**TECHNICAL BULLETIN**  
**Bell Helicopter** **TEXTRON**

No. 230-01-32

**MODEL AFFECTED:** 230

**SUBJECT:** FUEL VENT ASSEMBLY P/N 430-060-004-101,  
INTRODUCTION OF

Figure 1. Vent Tube Modification

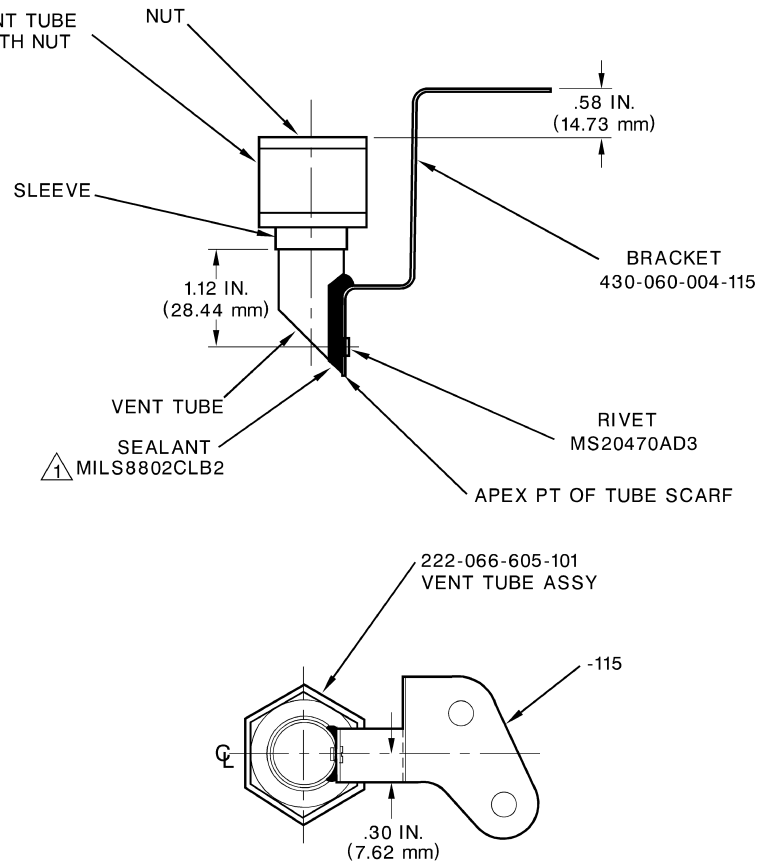
1. Remove existing fuel vent assembly P/N 222-066-605-101 from the prime pump plate. Refer to BHT-230-MM-4, Chapter 28.
2. Modify fuel vent assembly as follows:
  - a) Ensure sleeve and vent tube is fully seated into the nut.
  - b) Install bracket on the vent tube using rivet MS20470AD3-length. Refer to figure 1 for details and dimensions.
  - c) Apply sealant (C-308) to fill the space between vent tube and bracket. Refer to figure 1.

ENSURE SLEEVE & VENT TUBE  
ARE FULLY SEATED WITH NUT

1 Apply MILS8802CLB2 (C-308) sealant to fill space between the vent tube and the bracket.

Figure 2. Vent Tube Installation

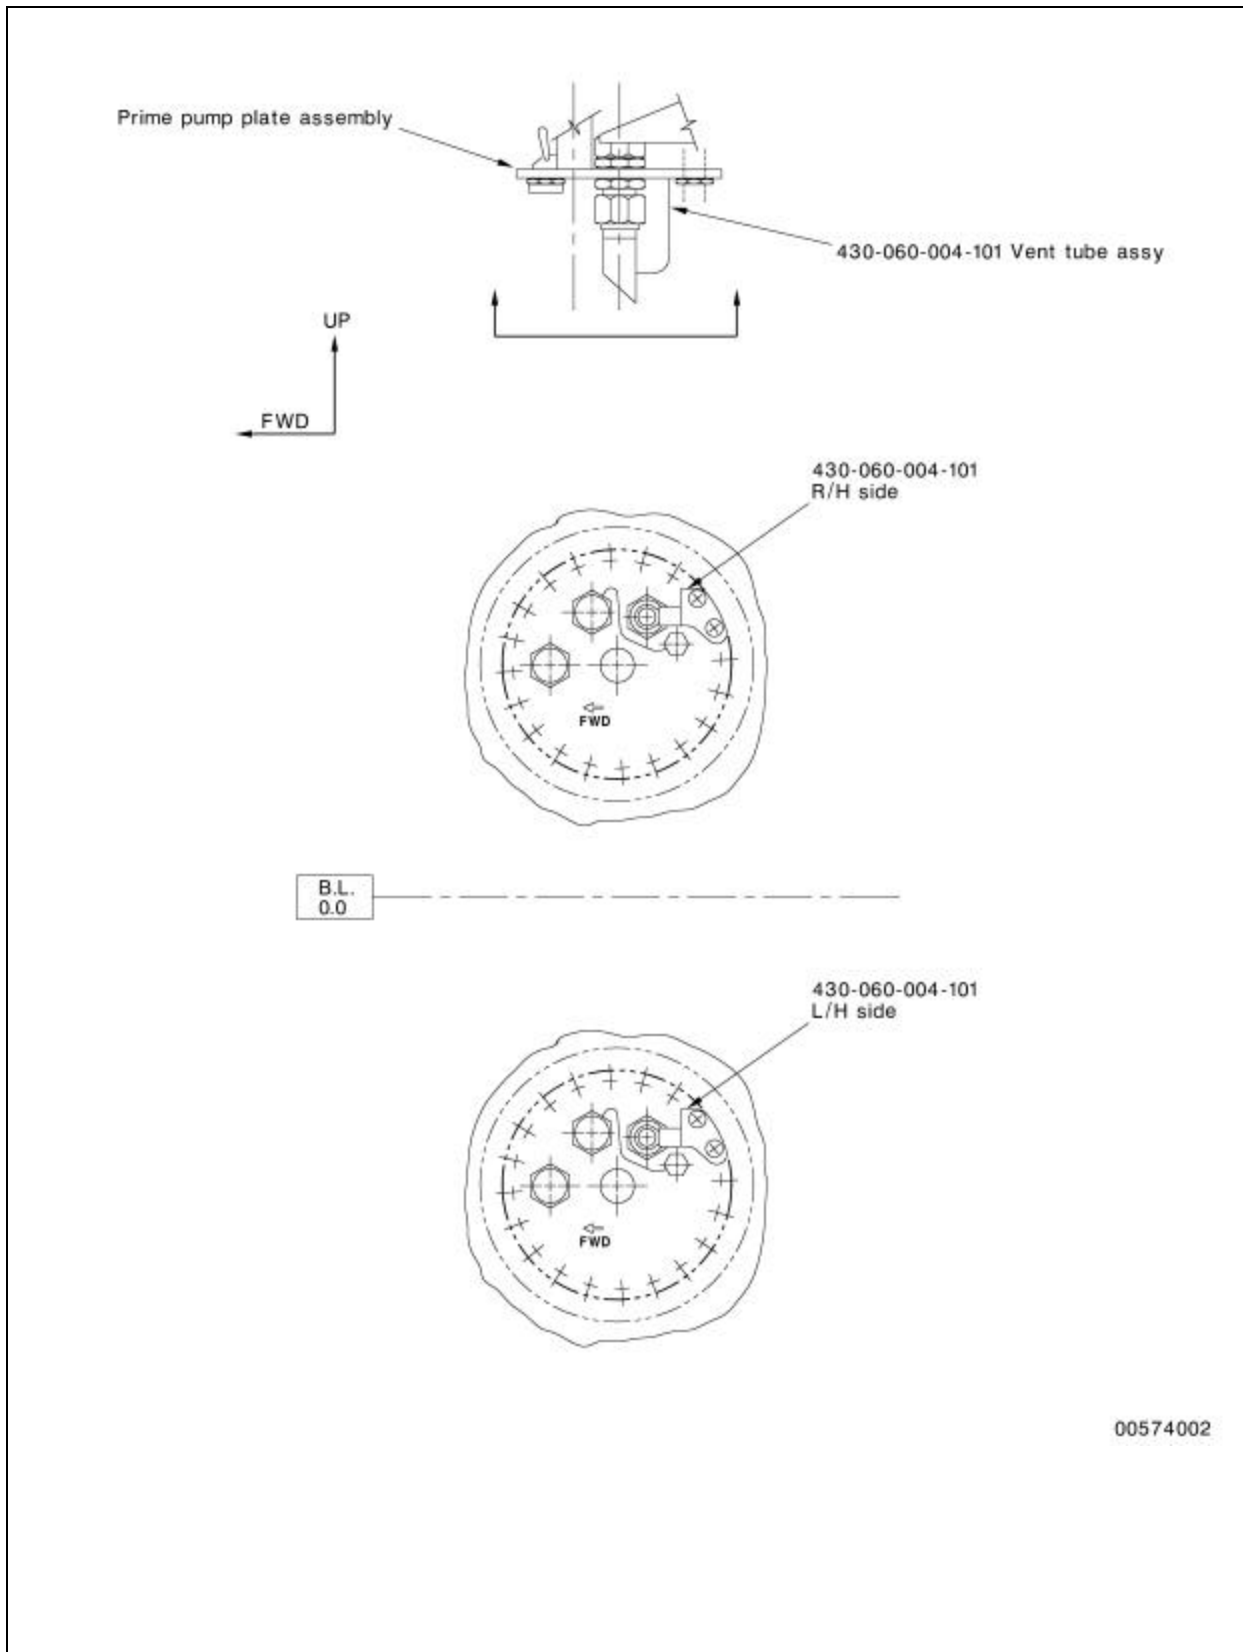
3. Remove two (2) prime pump plate retaining bolts and washers. Install modified fuel vent assembly or a new fuel vent assembly P/N 430-060-004-101 on the prime pump plate. Install retaining bolts and washers, previously removed, through the bracket and into the prime pump plate. Refer to BHT-230-MM-4, Chapter 28 and figure 2.
4. Annotate aircraft records to reflect compliance with this bulletin.
